REMARKS

**(ANNOTATED SHEETS SHOWING CHANGES OF FIGS. 6, 9, 13, & 16,
AND REPLACEMENT FORMAL DRAWINGS OF FIGS. 6, 9, 13, & 16)**

(Serial No. 10/613,277)

FIG. 6

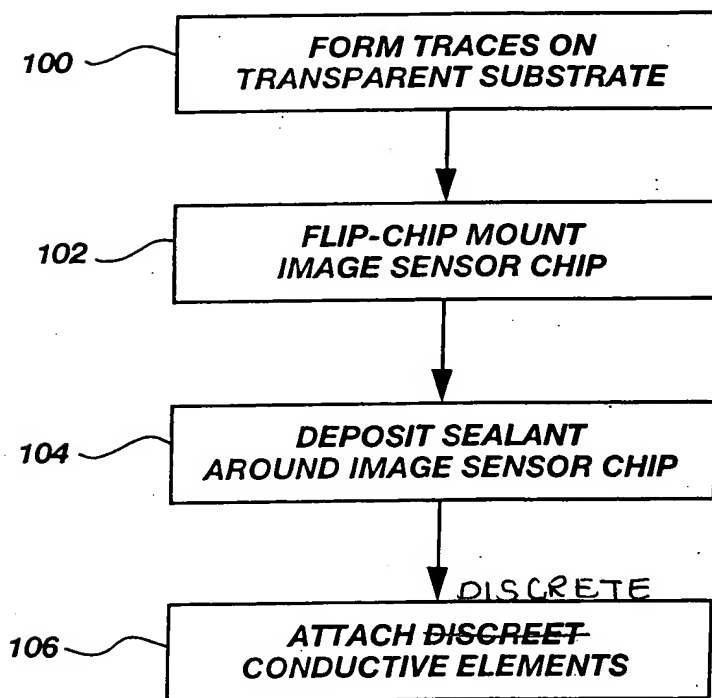
The attached sheets of drawings include changes to FIGS. 6, 9, 13, and 16. The word "DISCREET" has been corrected to "DISCRETE." The sheets, which include FIGS. 5, 6, 9, 10, 13, and 16, replace the original sheets including FIGS. 5, 6, 9, 10, 13, and 16.
